Access Compliance Report

Public Rights-of-Way

Intersection ID: 50271	Main Street: CLANTON_RD	Cross Street: SOUTH_BV	Location: NW
ADA ID: 3E2A664FE834	Ramp Type: ParaDiag	Initial Pass/Fail: Fail	Overall Compliance: No
			Severity Score: 13.75

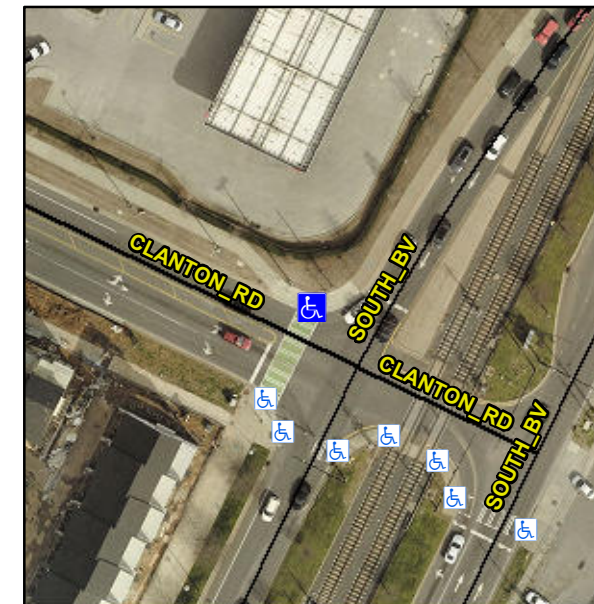
LT RP < 5%

R304.3.2, R304.5.3

Compliance	Description	Data	Compliance	Description	Data
N/A	Ramp Length LT (in)	89.0	N/A	Ramp Length RT (in)	108.0
Yes	Ramp Width LT (in)	83.0	Yes	Ramp Width RT (in)	83.0
Yes	Ramp Slope LT (%)	2.6	No	Ramp Slope RT (%)	8.7
Yes	Ramp XSlope LT (%)	1.9	No	Ramp XSlope RT (%)	3.8
N/A	Landing Length (in)	N/A	N/A	DWS Provided?	N/A
N/A	Landing Width (in)	N/A	N/A	DWS Contrast?	N/A
N/A	Landing Slope (%)	N/A	N/A	DWS Length (in)	N/A
N/A	Landing X Slope (%)	N/A	N/A	DWS Full Width?	N/A
N/A	Landing Curb? (Y/N)	N/A	N/A	DWS Offset (in)	N/A
N/A	Shared Landing?	N/A			
N/A	Gutter Ponding?	N/A	N/A	Gutter Slope (%)	N/A
N/A	Gutter Lip Ht (in)	N/A	N/A	Gutter X Slope (%)	N/A
N/A	Painted X Walk1?	Yes	N/A	Painted X Walk2?	No
	X Walk 1 Direction	To SW		X Walk 2 Direction	To SE
N/A	X Walk 1 Width (in)	152.0	N/A	X Walk 2 Width (in)	N/A
	X Walk 1 Slope (%)	2.5		X Walk 2 Slope (%)	0.8
	X Walk 1 X Slope (%)	2.3		X Walk 2 X Slope (%)	2.7
N/A	Ramp inside XWalk1?	Yes	N/A	Ramp inside XWalk2?	N/A

Remove & Replace Curb Ramp With Two New Directional Ramps or Equivalent.
